Item Name: Crosstube Turning Detail

DART AEROSPACE LTD		Work Order:	140424
Description: Crosstube Assembly		Part Number:	D407-667-145
Inspection Dwg: D407-667-145 Rev: C		Page 1 of 2

DART AEROSPACE LTD HAWKESBURY, ONTARIO, CANADA	
DRAWING NO. D407-667-145	REV. C SHEET 1 OF 4
TITLE CROSSTUBE ASS'Y (407 HIGH FWD)	SCALE NTS

DRAWING NO. D407-667-145	TITLE CROSSTUBE ASS'Y (407 HIGH FWD)	REV. C	DART AEROSPACE LTD ENGINEERING ORDER		D.E.O. NO. D407-667-145-C-1	SHEET NO. SHEET 1 OF 1	SCALE NTS
DRAWN <i>92</i>	CHECKED <i>ASS</i>	MFG. APPR. <i>AB</i>	APPROVED <i>WD</i>		DE APPR. <i>HA</i>		
DATE 11.07.15	DATE 11.07.22	DATE 11.07.22	DATE 11/07/22		DATE 11.07.21

C TURNING DETAIL

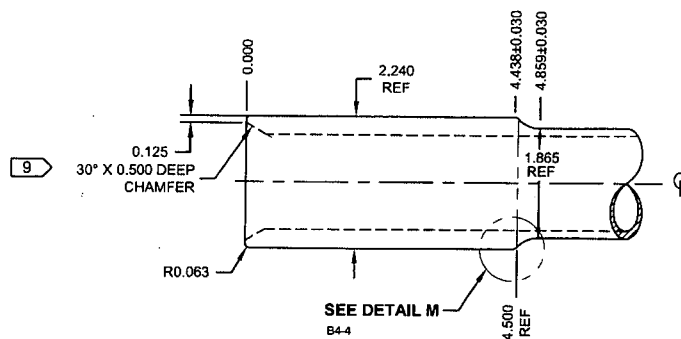
C	REVISE GENERAL NOTES/PART LIST (ZN D7-1); REORGANIZED VIEWS AND REFORMATTED DRAWING TO CURRENT STANDARDS. D3595-063-395 WAS D2856-400-694 (ZN D6-2 & A5-2); REMOVED REF. 7 ADD TOLERANCES (ZN C6-3, C4-3, D2-3); RELOCATED FLAG #6 (ZN A8-3) PER NCR 210; MOVED TURNING DETAIL & UPDATED TOLERANCE TO SHEET 4.	RF	08.11.06
B	ADD HOLES AND NUT PLATES FOR COMPATABILITY WITH BHT/AA SKUDTUBES	PH	05.07.26
A	NEW ISSUE	CP	02.05.08
REV.	DESCRIPTION	BY	DATE
DESIGN	9		
DRAWN	RF		
CHECKED	9		
MFG. APPR.	9		
APPROVED	9		
DE APPR.	9		
DATE	08.11.06

DETAIL P
 BONDING STRAP INSTALLATION 2 PL

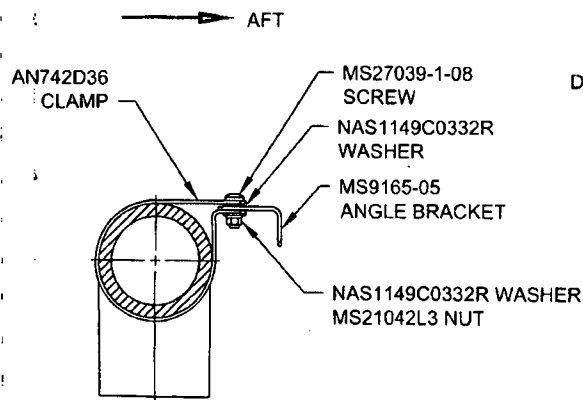
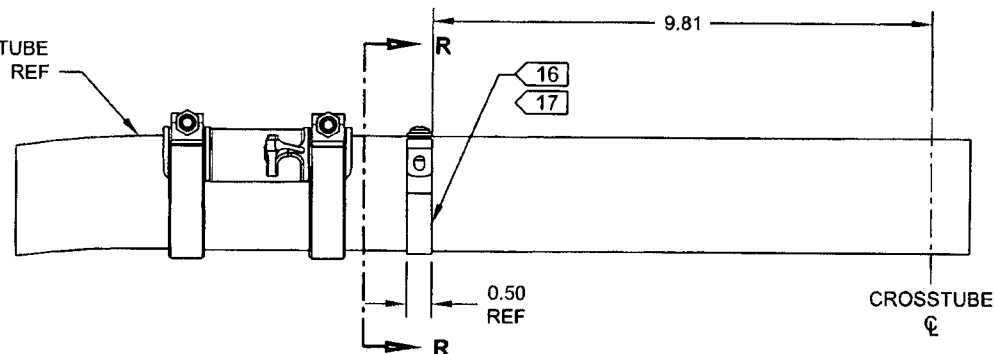
PURPOSE:

ADD ELECTRICAL GROUNDING STRAP

ITEM	QTY	PART NUMBER	DESCRIPTION
1	X	D407-667-145	CROSSTUBE ASSEMBLY (407 HIGH FWD)
10	2	AN742D36	CLAMP
11	2	MS9165-05	ANGLE BRACKET
12	2	MS21042L3	NUT (OR MS21042-3)
13	2	MS27039-1-08	SCREW
14	4	NAS1149C0332R	WASHER (OR AN960C10L)

- 16) MASK AREA UNDER CLAMP PRIOR TO PAINTING
- 17) SEAL EDGES WHERE AN742D36 CLAMP MEETS WITH THE CROSSTUBE USING SIKAFLEX-241/-291 OR MIL-S-8802 CLASS B2 OR PROSEAL 890 SEALANT
- 18) PERFORM RESISTANCE CHECK TO ENSURE MAX RESISTANCE IS 10 MILLIOHMS
